AMENDMENT OF SOLICITATION/MODIFICATION OF CONTRACT				1. CONTRACT ID CODE		PAGE OF PAGES	
2. AMENDMENT/MODIFICATION NO. 0001		3. EFFECTIVE DATE 15-Jun-2023		4. REQUISITION/PURCHASE REQ. NO.		5. PROJECT NO.(If applicable)

14. DESCRIPTION OF AMENDMENT/MODIFICATION (Organized by UCF section headings, including solicitation/contract subject matter where feasible.) The above numbered Solicitation for Grand Isle and Vicinity, LA, Hurricane Ida Repairs, Dune and Beach Construction, Jefferson Parish, Louisiana has been amended to: a) Provide amended plans and specifications. b) Provide answers to prior questions. c) All questions are due NLT 11:00am CST on June 22, 2023 e) Bid submission date changed to June 29, 2023, at 1:30pm CST. Virtual Bid opening instructions included.							
Except as provided herein, all terms and conditions of the document referenced in Item 9A or 10A, as heretofore changed, remains unchanged and in full force and effect.							
15A. NAME AND TITLE OF SIGNER (Type or print)				16A. NAME AND TITLE OF CONTRACTING OFFICER (Type or print)			
				TEL: EMAIL:			
15B. CONTRACTOR/OFFEROR		15C. DATE SIGNED		16B. UNITED STATES OF AMERICA		16C. DATE SIGNED

Grand Isle and V

SHEET IDENTIFICATION		G-03	
-------------------------	--	------	--

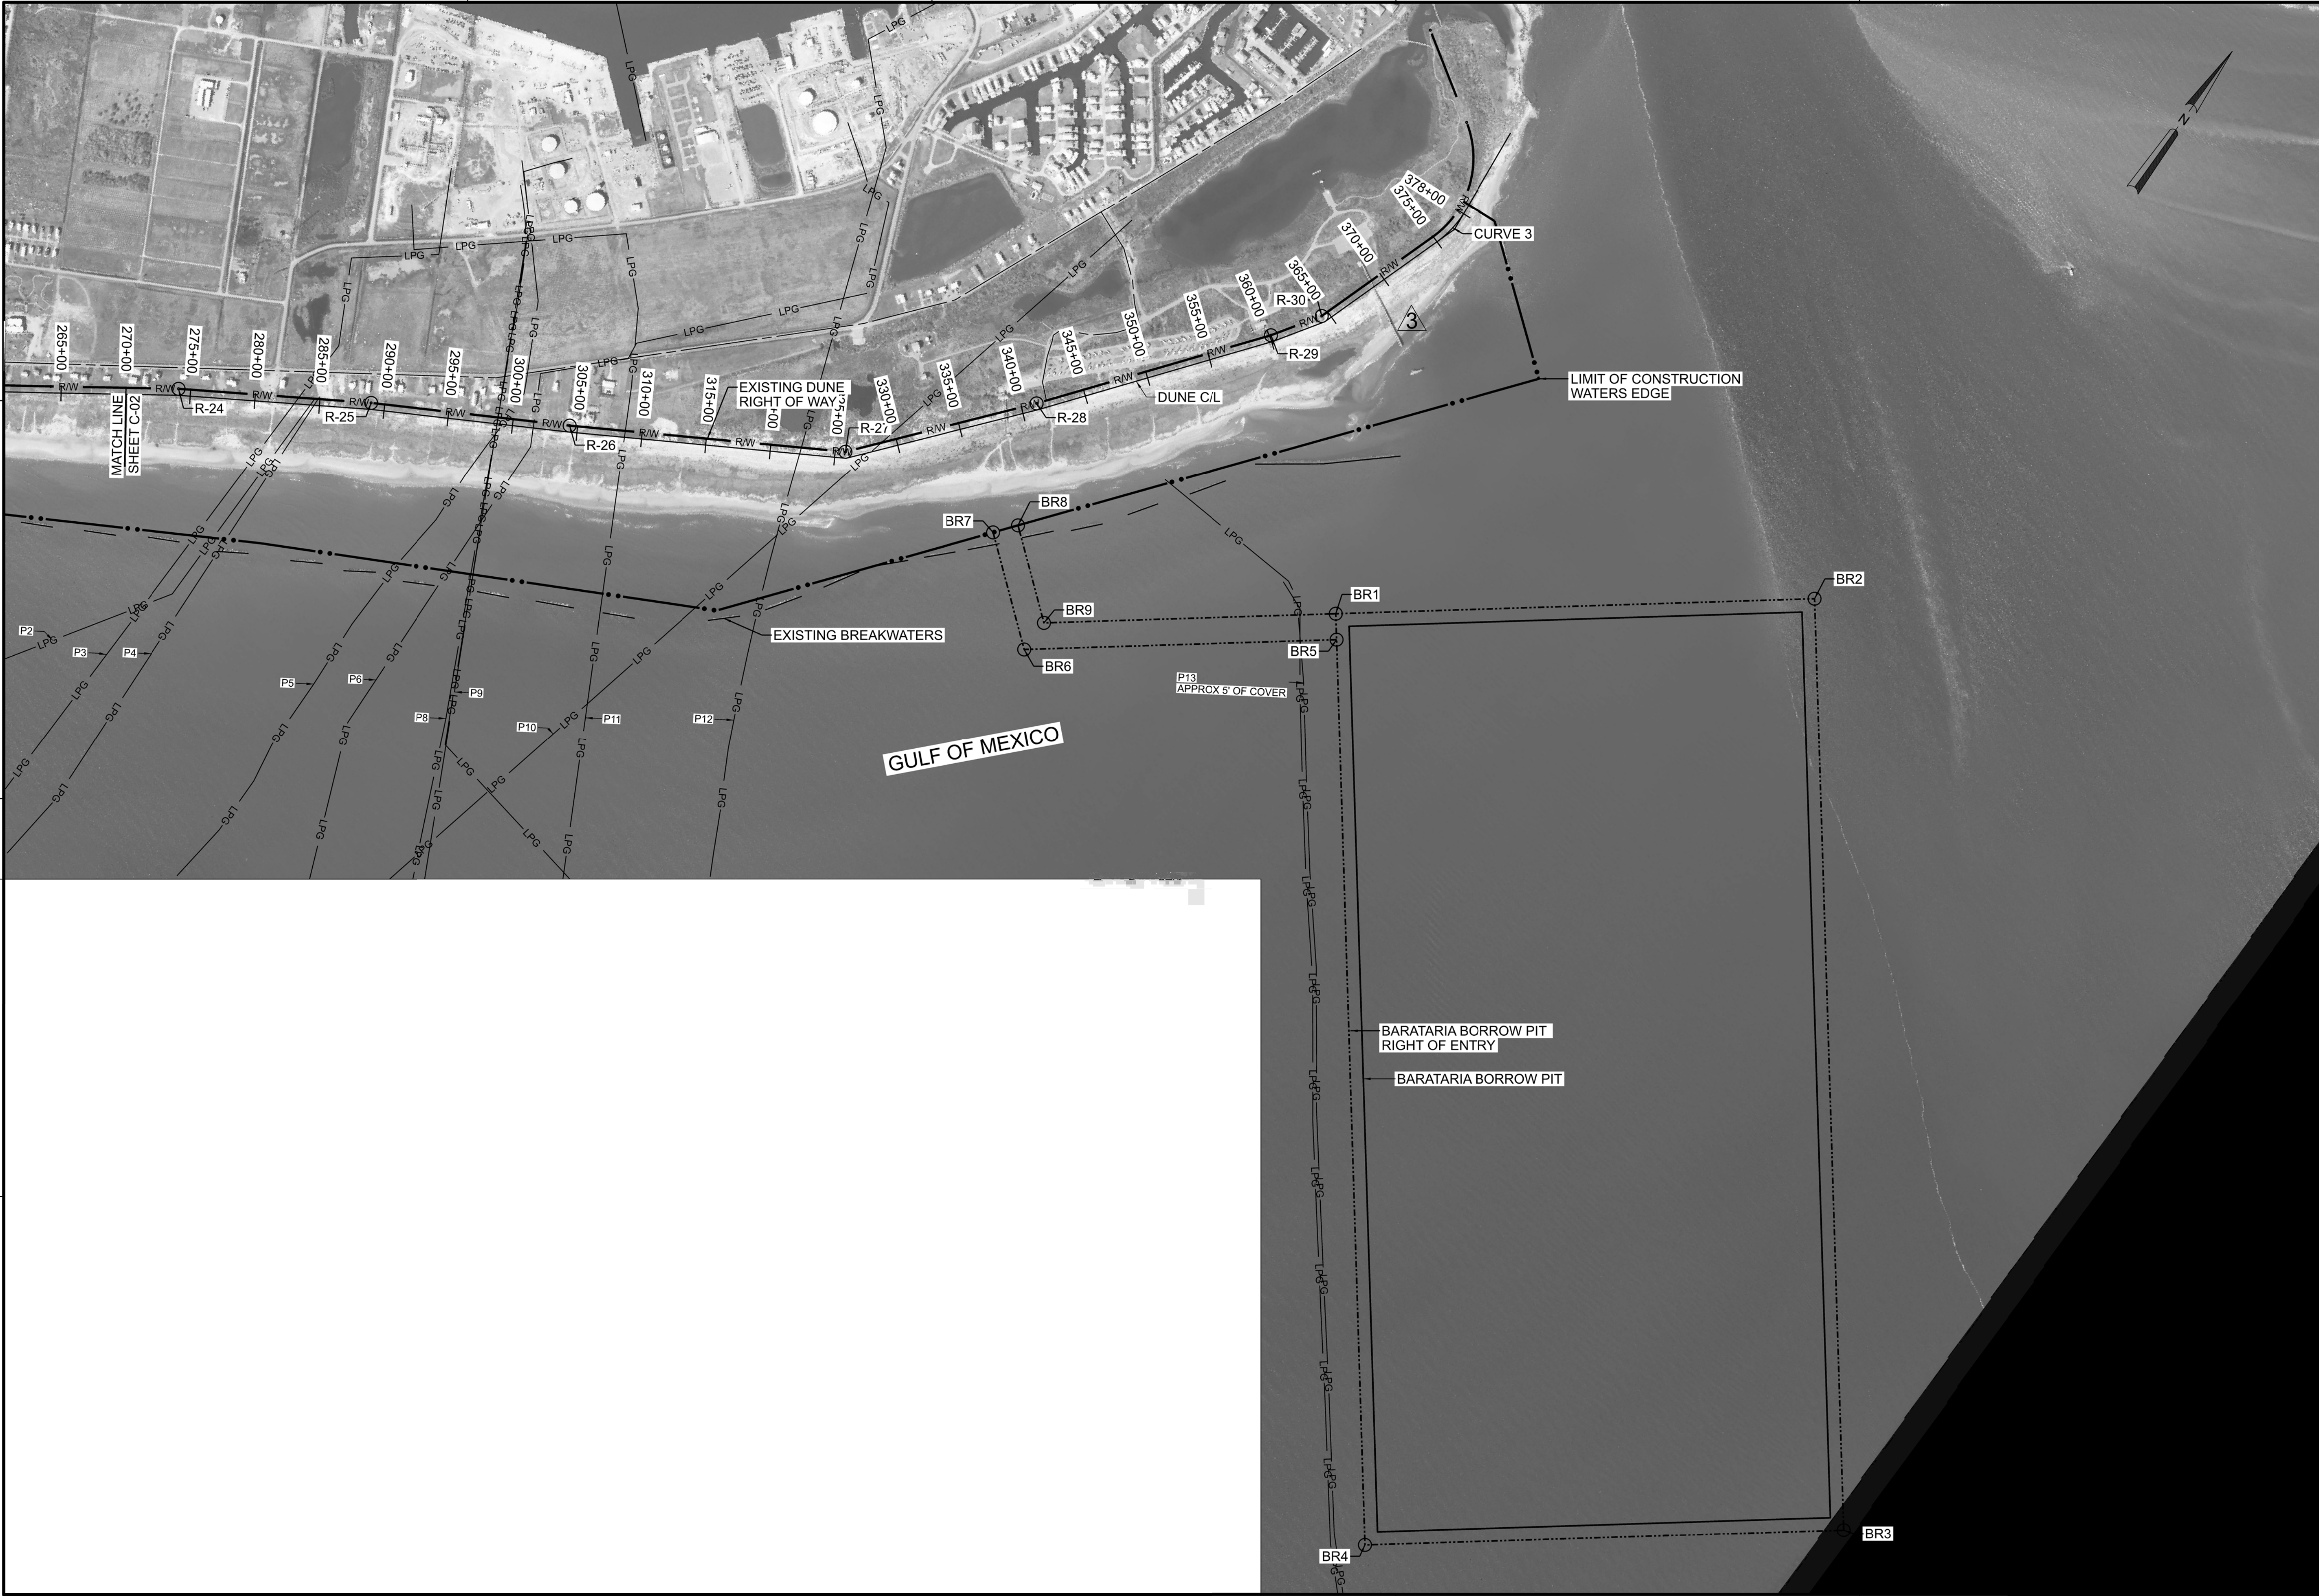
1. SHEET IDENTIFICATION Nos. G-03, C-01, C-03, C-21, and C-37. Delete these drawings in their entirety and substitute the attached revised drawings SHEET IDENTIFICATION Nos. G-03, C-01, C-03, C-21, and C-37, therefore.
2. Add the attached new drawing SHEET IDENTIFICATION No. C-21.
